CITY OF VAN METER, IOWA
VAN METER COMMUNITY SCHOOL DISTRICT
BUILDING ADDITION AND RENOVATION
SITE PLAN REVIEW

On April 8, 2014, the writer received from Clapsaddle-Garber Associates, Inc. the following documents constituting the site plan for the Van Meter Community School District Building Addition and Renovation project:

FACILITIES MASTER PLAN
 VAN METER
 COMMUNITY SCHOOLS
 VAN METER, IOWA

ISSUE DATE	ISSUE TITLE
Mar. 21, 2014	
REVISION DATE	REVISION TITLE
XX-XX-XX	PROJECT MILESTONE
JOB NUMBER	1092
SHEET NAME	OVERALL LAYOUT AND UTILITY PLAN
SHEET NUMBER	C.200

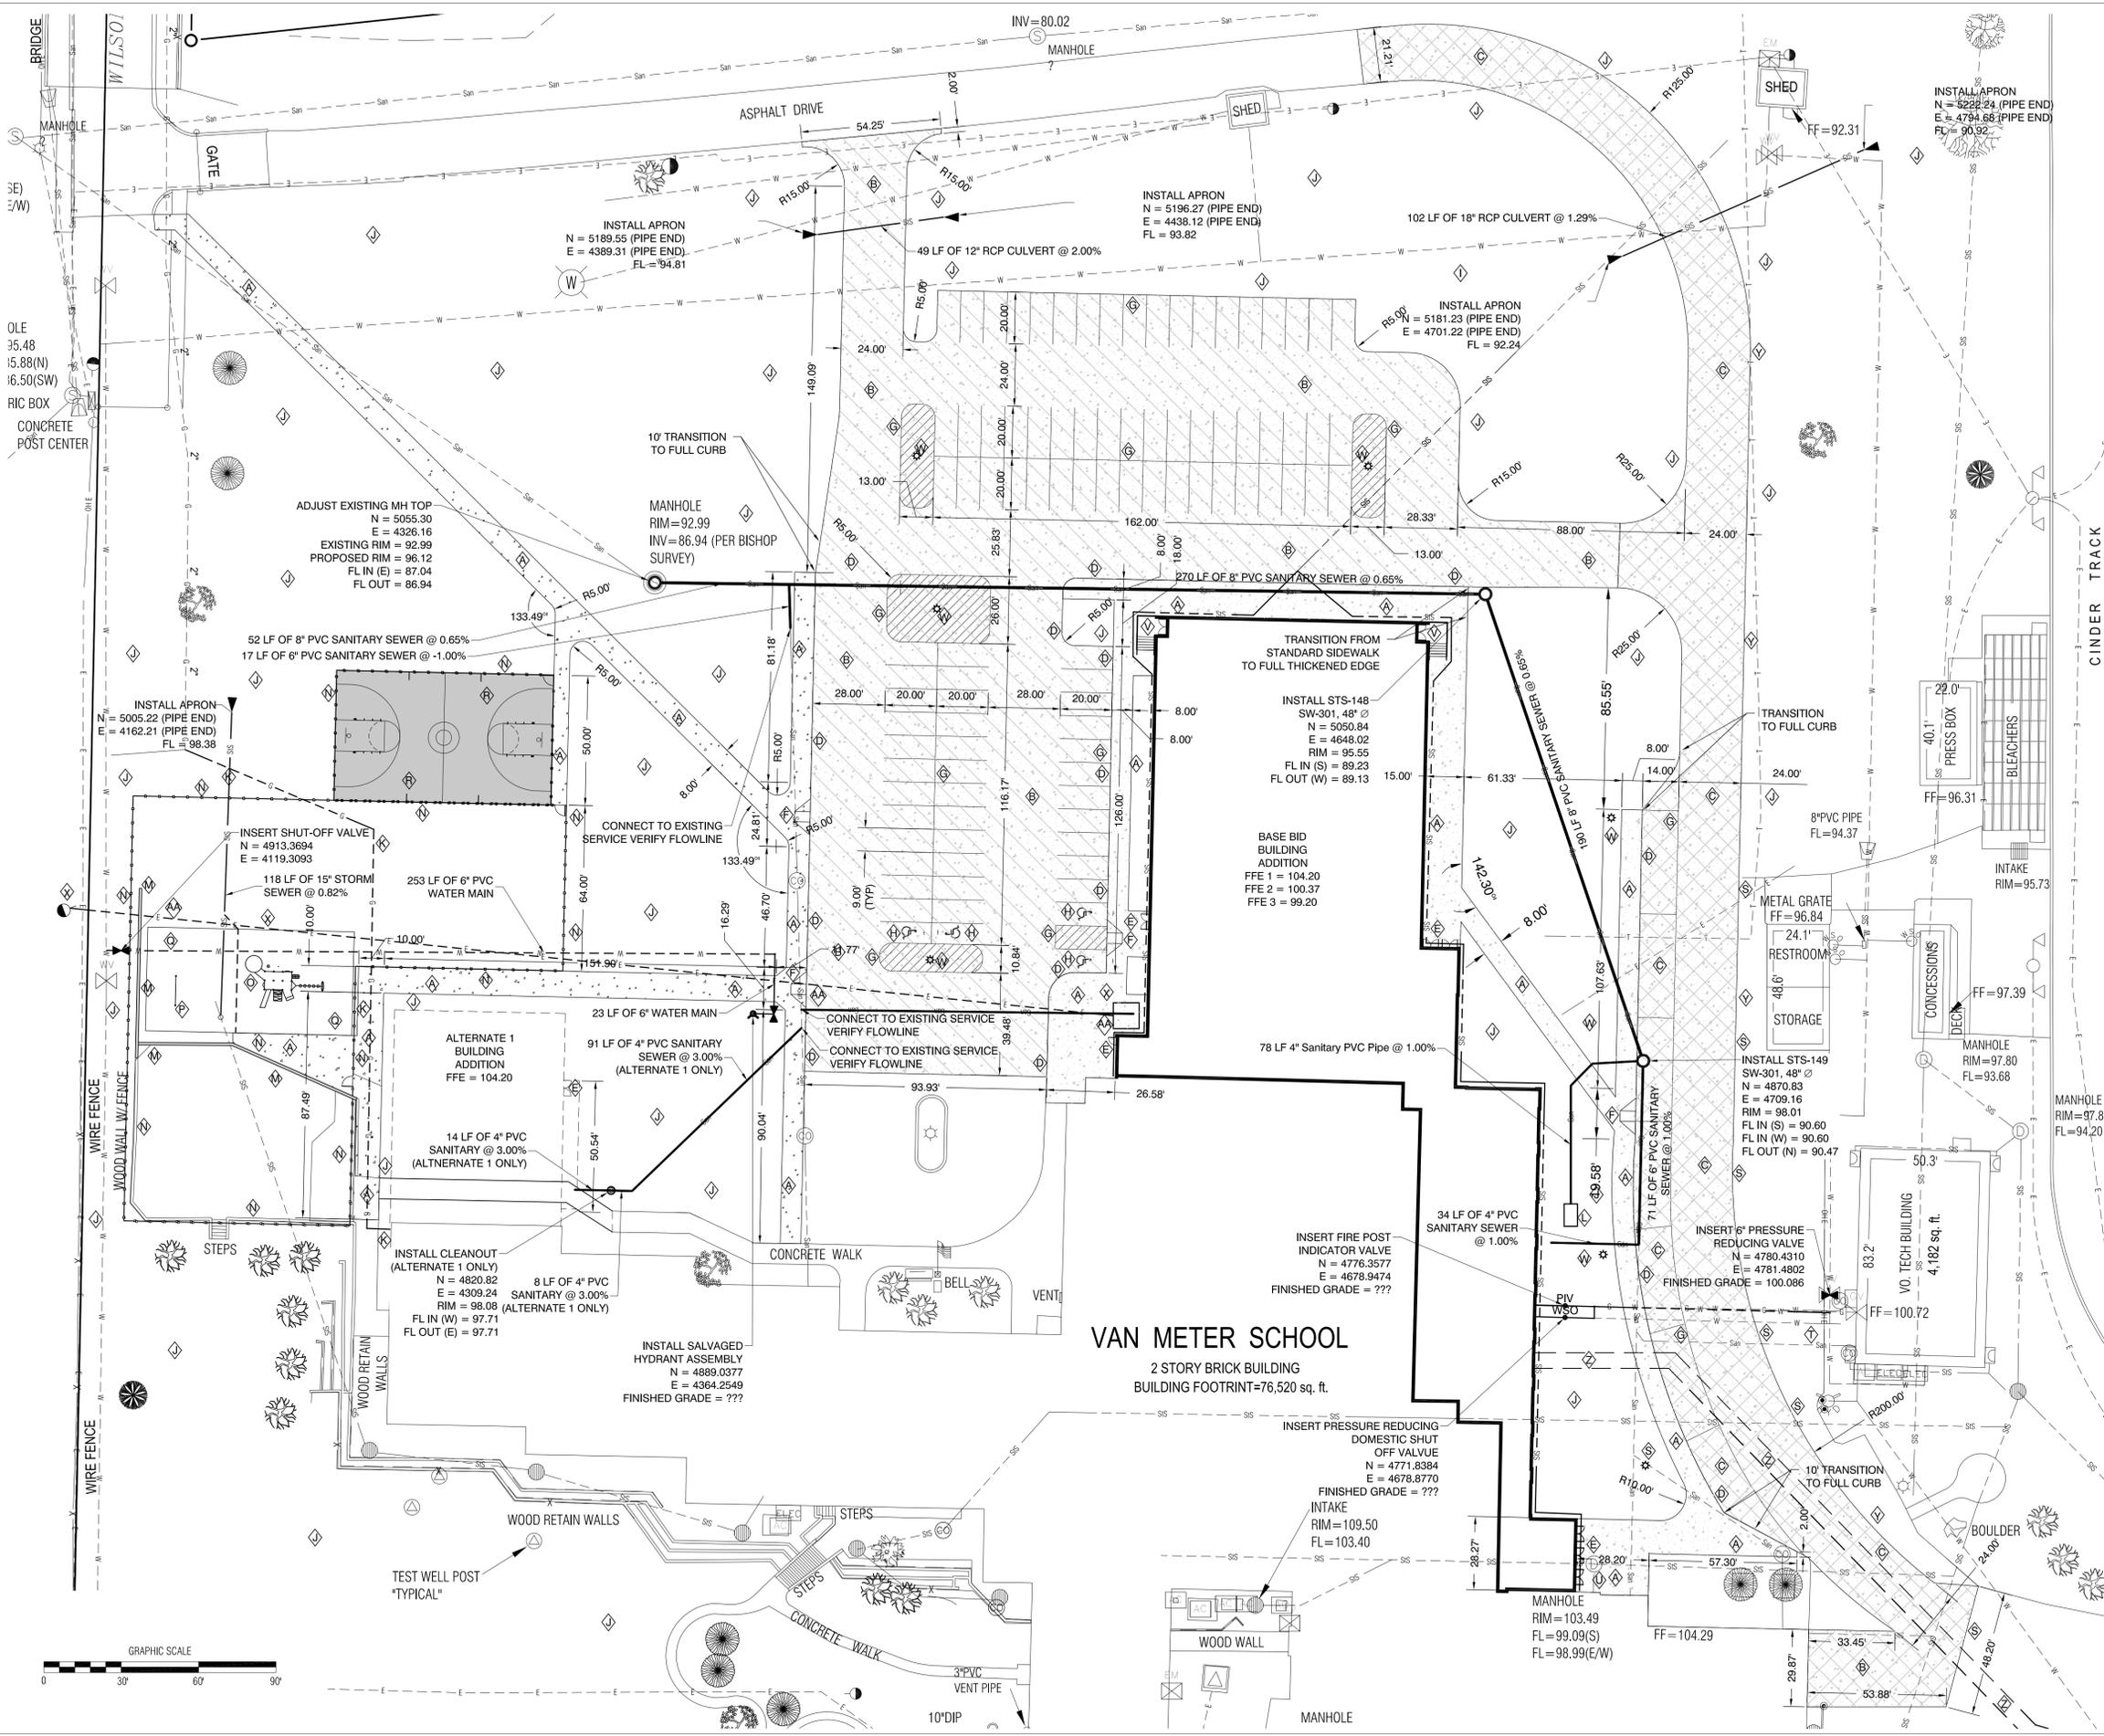
- ✓ 4. The site plan shows proposed modifications to the water system that would convert the existing 6-inch water main extending west from Richland Road from the City's low pressure system to the City's high pressure system. This modification is to allow the fire service to the new building facility to be on the high pressure system to provide adequate pressure.

- ✓5. The writer understands the cost effective method for the school to meet its requirements for sprinkling would be a high pressure connection. The writer believes the City should work with the school district to achieve a high pressure zone connection to the school for its fire service line.

- ✓6. The building and hydrant on the west side of the building would remain on the low pressure system as converting the entire building to high pressure would result in excessive pressure for normal usage at the building.

- ✓7. The site plan shows a 6-inch valve to be installed by the City on the water main on the west side of Richland Road. The transmittal letter suggests the City relocate its pressure sustaining and regulating valve located at 352nd northerly to allow the 6-inch water main to be converted to the high pressure zone. To implement this change it would be necessary to relocate the pressure sustaining valve to add the valve shown in the plans and to construct a water main across Richland Road to maintain the existing 6-inch water main north of the school drive on the low pressure zone.

- 8. The site plan shows the addition of two valves on the water main on the east side of the existing building to isolate the water main along the access drive from the balance of the low pressure water main. This configuration would result in the 6-inch water main leading from the ground storage reservoir northeast to be isolated and become a dead end main. The valve near the Vo Tech building eliminates the looping within the site on the low pressure system.

- 9. Based on initial review, the writer is not supportive of the configuration shown on the site plan. The writer believes it would be preferable to maintain the water main loop along the east side of the school, including the connection to the ground storage reservoir. To maintain the loop it appears necessary to construct approximately 200 feet of additional water main to extend the fire service line to the east west water main on the access drive. This water main would be separated from the low pressure loop along the east side of the school to provide the high pressure connection while maintaining the low pressure loop along the east side of the school.

11. The site plan appears to show the addition of a water main extending from the north south water main easterly to a service connection and hydrant located near the southwest corner of the new parking lot area.

12. It is requested the site plan include hydrant coverage circles to show with a 300-foot radius to show the building is adequately covered by hydrant locations.

13. The location of hydrants, both new and existing, should be reviewed with the appropriate representatives of the fire department relative to the logistics of firefighting operations.

ISSUE DATE	ISSUE TITLE
Mar. 21, 2014	
REVISION DATE	REVISION TITLE
XX-XX-XX	PROJECT MILESTONE
JOB NUMBER	1092
SHEET NAME	Joining Plan
SHEET NUMBER	C.230

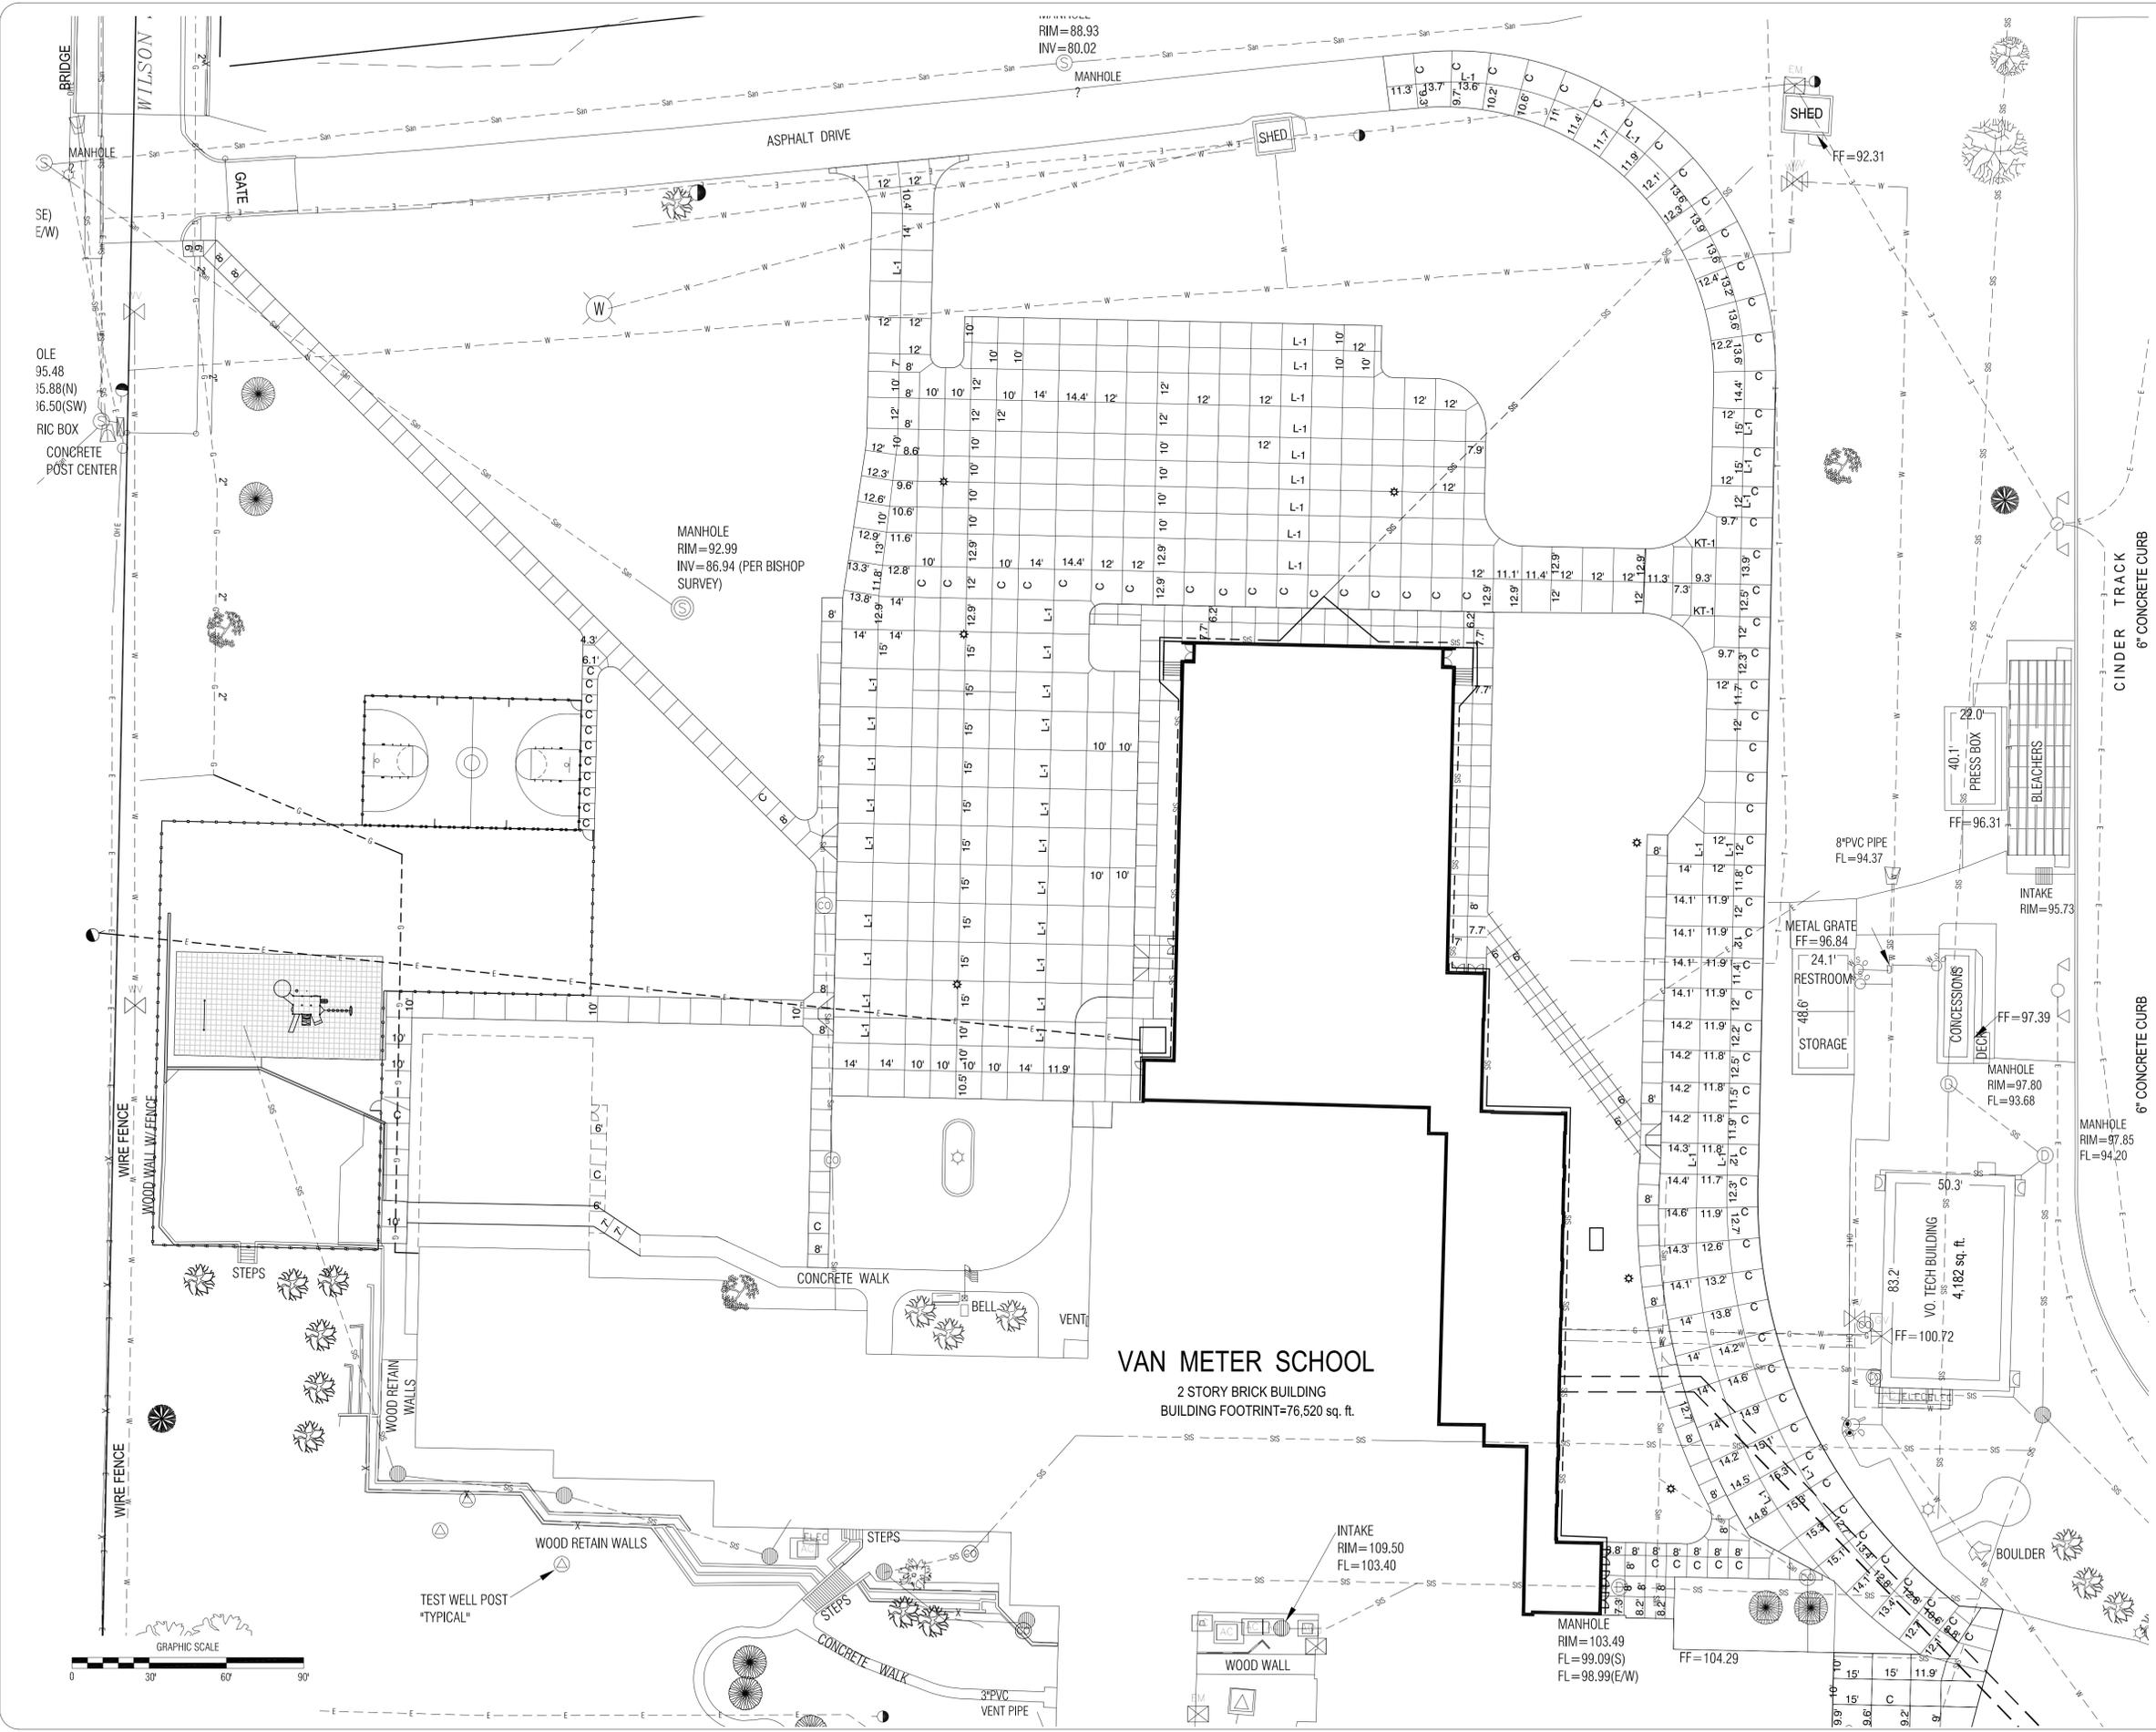
20. The site plan shows the location configuration and jointing pattern for the driveway and parking lot addition. Because these improvements are privately owned the City does not provide specific comments relative to the design details.
